Subject: Valley Vista Lot Split

Subject: FW: Tonight's planning commission public hearing regarding 4474 and 4490 E. Valley

Please reference the email below regarding the Preliminary Plat/Private Road CUP at Valley Vista Lane.

A significant arroyo. Deep and wide.JPG ×

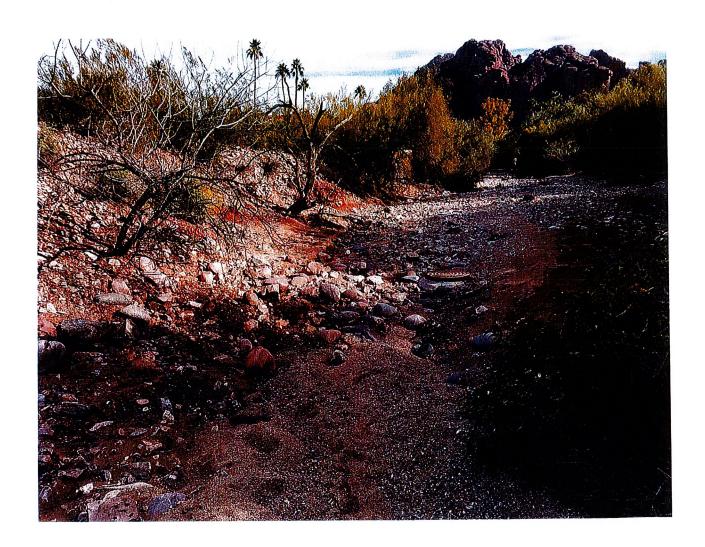
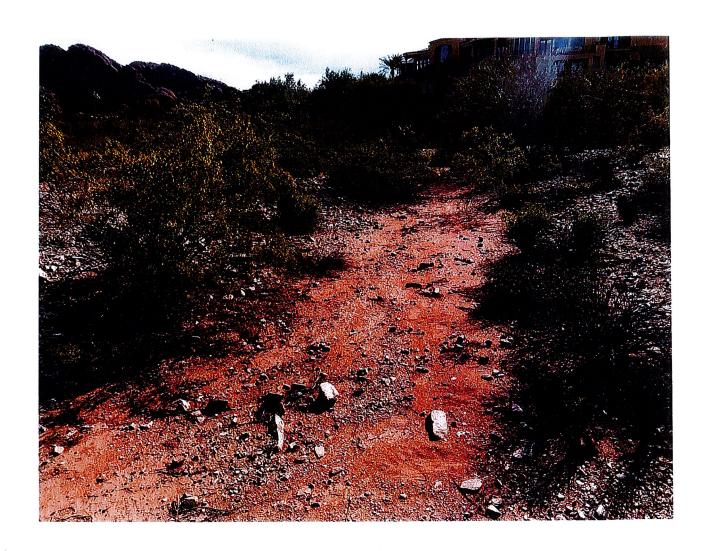
I am attaching photos taken on the island lot that is being considered for development and from the arroyo that divides the two properties on which the developer wishes to build. The photos show how much water/wash goes through the middle of the island lot to the degree it is creating a third arroyo. This third arroyo was not represented at all in the renderings. The main source of this water is through our property. Attached is a google earth picture that clearly shows the third arroyo.

Included also are pictures of the arroyo between the properties in question showing how deep and wide it is. The bridge and waterway are fancifully under represented in the renderings. I have attached the renderings for comparison purposes.

I hope these pictures will lead you to understand why any development on this lot is troublesome due to water run off management. We have an example of faulty arroyo management already in our neighborhood and want to avoid a repeat.
